Product Change Notification

Change Notification #: 115677 - 00
Change Title: Intel® Dual Band Wireless-N 7260
SKUs:7260.HMWANG.I; 7260.HMWNBG
PCN 115677-00, Label, Product Marking,
Label and Silkscreen Update
Date of Publication: July 18, 2017

Example of CE mark change on PCB artwork

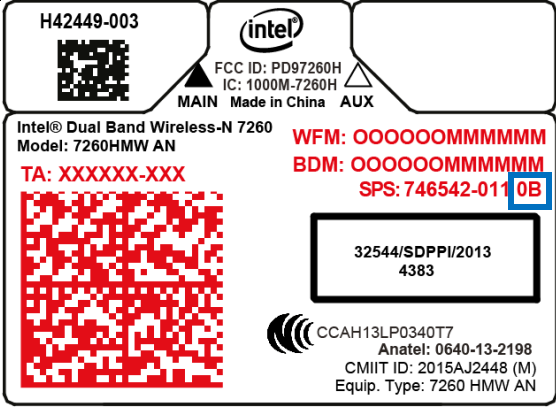
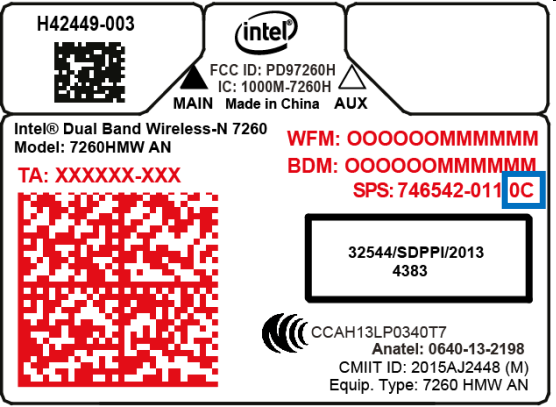
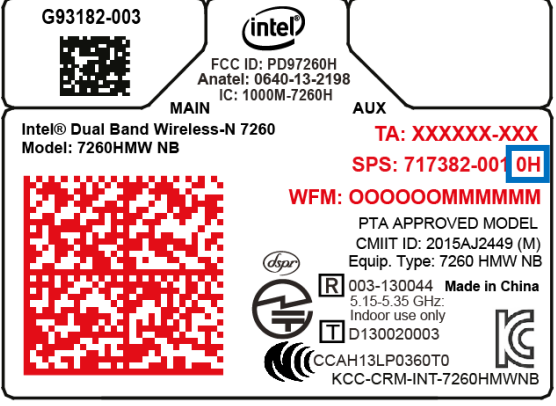
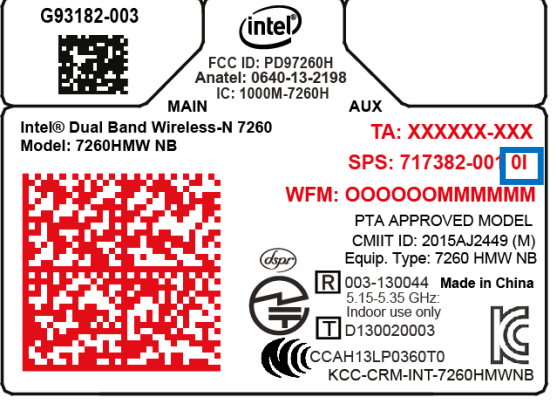
- Two selected SKU's in the Intel® Dual Band Wireless-AC 7260 product family has been re-activated to accommodate a last time buy. As a result we will be updating the SKU to be compliant with the new European Radio Equipment Directive 2014/53/EU and to make the following updates. Changes will appear as below.
- European Radio Equipment Directive 2014/53/EU update
 - The current CE ! Mark on the module will be modified to remove the Alert Symbol (!) following the CE mark.

Label Artwork (Before/After)

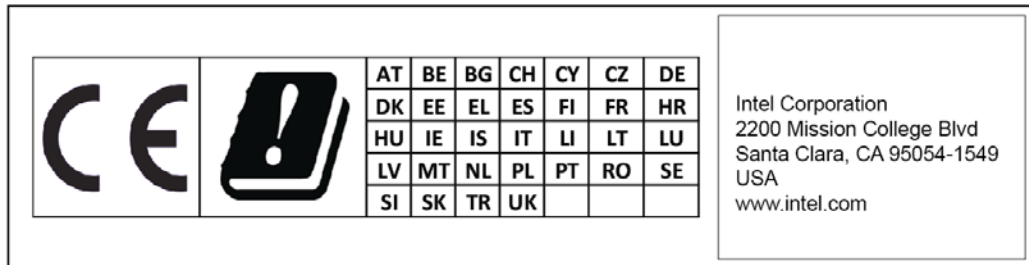
Product Code	Before	After
7260.HMWANG.I	 <p>H42449-003 FCC ID: PD97260H IC: 1000M-7260H MAIN Made in China AUX</p> <p>Intel® Dual Band Wireless-N 7260 Model: 7260HMW AN TA: XXXXXX-XXX WFM: OOOOOMMMMMM BDM: OOOOOMMMMMM SPS: 746542-011 0B</p> <p>32544/SDPPI/2013 4383</p> <p>CCAH13LP0340T7 Anatel: 0640-13-2198 CMIIT ID: 2015AJ2448 (M) Equip. Type: 7260 HMW AN</p>	 <p>H42449-003 FCC ID: PD97260H IC: 1000M-7260H MAIN Made in China AUX</p> <p>Intel® Dual Band Wireless-N 7260 Model: 7260HMW AN TA: XXXXXX-XXX WFM: OOOOOMMMMMM BDM: OOOOOMMMMMM SPS: 746542-011 0C</p> <p>32544/SDPPI/2013 4383</p> <p>CCAH13LP0340T7 Anatel: 0640-13-2198 CMIIT ID: 2015AJ2448 (M) Equip. Type: 7260 HMW AN</p>
7260. HMWNBG	 <p>G93182-003 FCC ID: PD97260H Anatel: 0640-13-2198 IC: 1000M-7260H MAIN AUX</p> <p>Intel® Dual Band Wireless-N 7260 Model: 7260HMW NB TA: XXXXXX-XXX SPS: 717382-001 0H WFM: OOOOOMMMMMM</p> <p>PTA APPROVED MODEL CMIIT ID: 2015AJ2449 (M) Equip. Type: 7260 HMW NB</p> <p>003-130044 Made in China 5.15-5.35 GHz Indoor use only D130020003</p> <p>CCAH13LP0360T0 KCC-CRM-INT-7260HMWNB</p>	 <p>G93182-003 FCC ID: PD97260H Anatel: 0640-13-2198 IC: 1000M-7260H MAIN AUX</p> <p>Intel® Dual Band Wireless-N 7260 Model: 7260HMW NB TA: XXXXXX-XXX SPS: 717382-001 0I WFM: OOOOOMMMMMM</p> <p>PTA APPROVED MODEL CMIIT ID: 2015AJ2449 (M) Equip. Type: 7260 HMW NB</p> <p>003-130044 Made in China 5.15-5.35 GHz Indoor use only D130020003</p> <p>CCAH13LP0360T0 KCC-CRM-INT-7260HMWNB</p>
